SI0299

Equipment Affected: OptiView Control Panel Retrofit Kits for YT and YK Chillers

VSD Modbus Comms Upgrade for OptiView Control Panel Retrofit Kits

FIGURE 1 - 035-21565-000 FOR MODEL VSD DRIVES

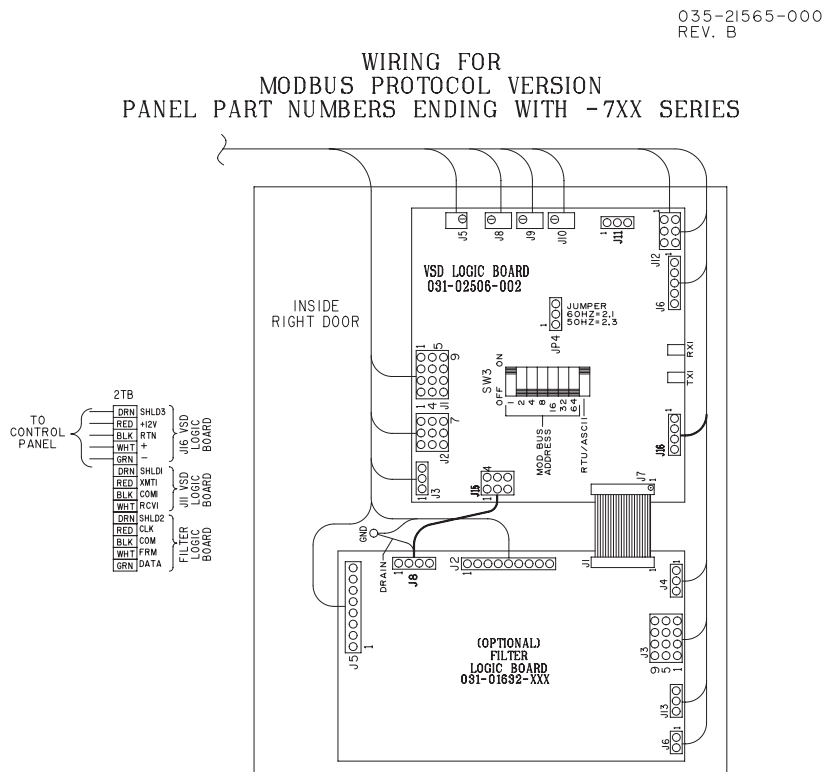
VSD SOFTWARE PART NUMBER	MODIFICATIONS
Model VSD - VSD software part number 031-02547-XXX	No hardware changes Change logic board wiring and settings per 035-21565-000 (see Figure 1)
Model VSD - VSD software part number 031-01617-XXX	Logic board upgrade kit (see Table 3 below) Modbus Wiring Modifications : 371-05193-002
Model TM-3 - VSD software part number 031-02547-XXX	No hardware changes Change logic board wiring and settings per 035-21563-000 (see Figure 2)
Model TM-3 - VSD software part number 031-01617-XXX	Logic board upgrade kit (see Table 3 below) Modbus Wiring Modifications: 371-05193-001

1. VSD logic bd. J11 unplugged
2. VSD logic bd. J16 plugged in
3. VSD logic bd. J15 plugged into J8 of filter logic bd. remove small cable attached to main harness for this connection.
4. VSD logic bd. SW3 positions I and RTU/ASCII on. All other positions off.
5. VSD logic bd. JP4 60hz or 50 hz appropriately for application.
